U.S. NUCLEAR REGULATORY COMMISSION
REGION III

Report No. 50-305/OL-87-01

Facility Name: Kewaunee

2. Examination Review Meeting

Figure 1
for question 5.11

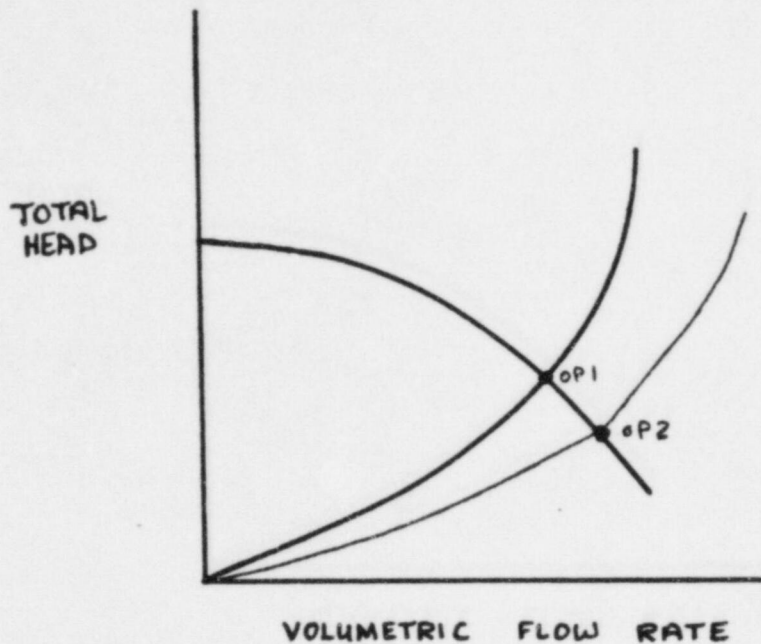
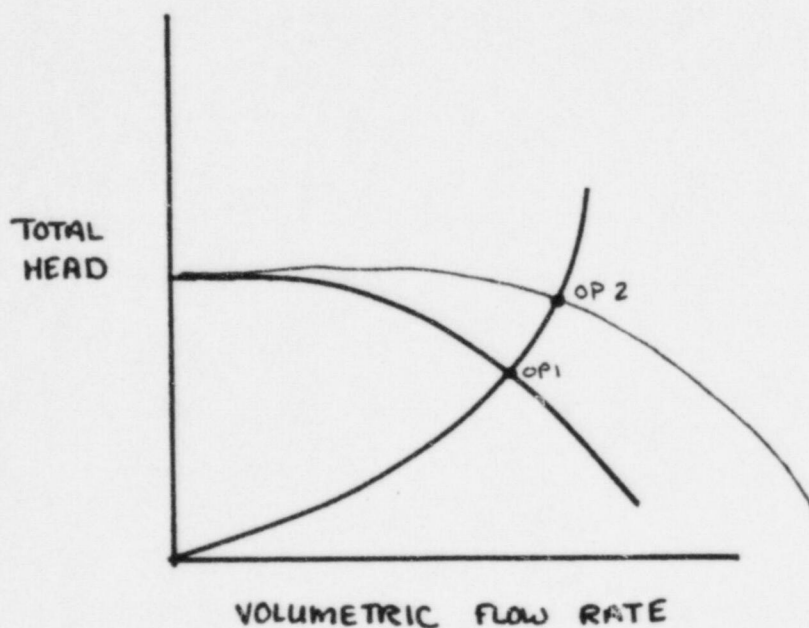
Facility Comment:

Comment accepted. Answer key modified to add comment. However, the stated answer is specifically noted in the reference mentioned.
